Access Compliance Report Public Rights-of-Way (Curb Ramps)

Main Street: CRAWFORD_CANYON_RD Cross Street: BARRETT_LN Location: S

ADA ID: RPRK211007175747 Ramp Type: Type 1 - Perpendicular Initial Pass/Fail: Fail Overall Compliance: No Severity Score: 2

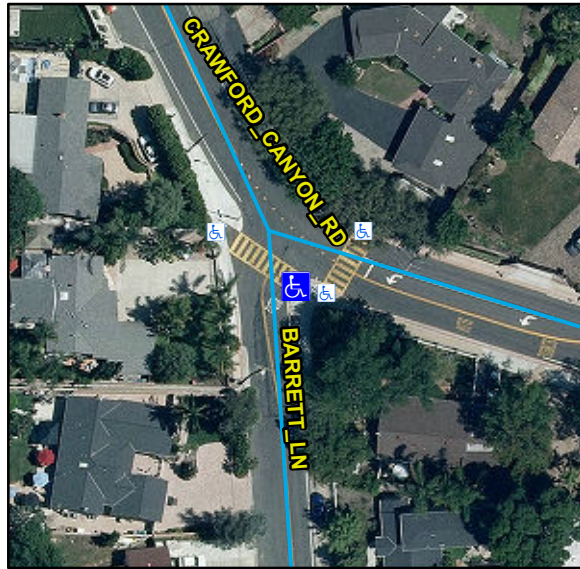
Compliance	Description	Data	Compliance	Description	Data
N/A	Ramp Length (in)	83	N/A	Flare Type LT	
Yes	Ramp Width (in)	48			N/A
Yes	Ramp Run Slope (%)	2.7	N/A	Flare Slope LT (%)	N/A
No	Ramp Cross Slope (%)	3.8	N/A	Flare Traversable LT	N/A
N/A	Landing Present	N/A	N/A	Flare Type RT	
N/A	Landing Length (in)	N/A			N/A
N/A	Landing Width (in)	N/A	N/A	Flare Slope RT (%)	N/A
N/A	Landing Run Slope (%)	N/A	N/A	Flare Traversable RT	N/A
N/A	Landing Cross Slope (%)	N/A	N/A	DWS Provided	N/A
N/A	Landing Movement Obstructed?	N/A	N/A	DWS Contrast	N/A
	Landing Movement Type	N/A	N/A	DWS Length (in)	N/A
N/A	Landing Shared	N/A	N/A	DWS Full Width	N/A
N/A	Clear Space	N/A	N/A	DWS Offset Left (in)	N/A
N/A	Clear Space To Crosswalk (in)	N/A	N/A	DWS Offset Right (in)	N/A
N/A	Marked Crosswalk 1	Yes	N/A	Marked Crosswalk 2	N/A
	Crossing 1 Direction	NW		Crossing 2 Direction	N/A
	Marked Crosswalk 1 Width (in)	144		Marked Crosswalk 2 Width (in)	N/A

N/A	Ramp Inside Crosswalk 1	Yes	Yes	Ramp Inside Crosswalk 2	N/A
	Crossing 1 Slope (%)	3.5		Crossing 2 Slope (%)	N/A
	Crossing 1 Cross Slope (%)	0.3		Crossing 2 Cross Slope (%)	N/A
N/A	Gutter Ponding	N/A	No	Curb Slope	10.3
Yes	Gutter Lip Height (in)	0		Road Run Slope (%)	N/A
N/A	Gutter Run Slope (%)	N/A		Road Cross Slope (%)	N/A
N/A	Gutter Cross Slope (%)	N/A			
Yes	Overall Surface Condition: Acceptable		Yes	Perp Joint Present	Yes
	Cross Gutter Present?	No		Spandrel Present?	No
	Replace Cross Gutter?	No		Replace Spandrel?	No

Remove & Replace Entire Ramp.

R304.2.2, R304.5.3, STD 1115
